Minutes of meeting – Copperstring

Hughenden Camp (Flinders Shire Council)

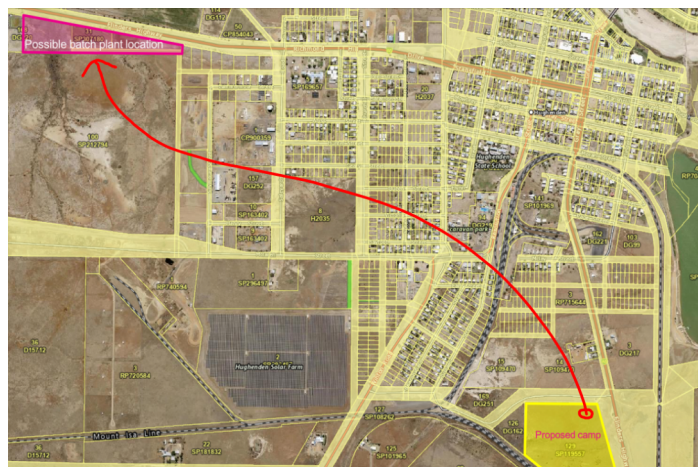
2.1.1. Hari mentioned the on-site wastewater disposal option would not be supported by Council for the site because (1) it is not suited to the residential area based on their town planning scheme and (2) there is council sewerage network available nearby if a connection is built to it.

2.1.3. Arthur mentioned we can add the Council preferred wastewater design to our revised set of concept plans, showing something like the following where a sewer line can head north (in red):

2.2.3. Hari objected to the use of drinking water supplies for use at the concrete batch plant and instead suggested such water should be obtained from their Bore #8 which is closer to town and has ample capacity and water can be obtained by trucks.

2.2.5. Andrew mentioned that the best place to secure drinking water from was from the 100mm main running along the Flinders highway. (See image above – blue lines show proposed route of connection).
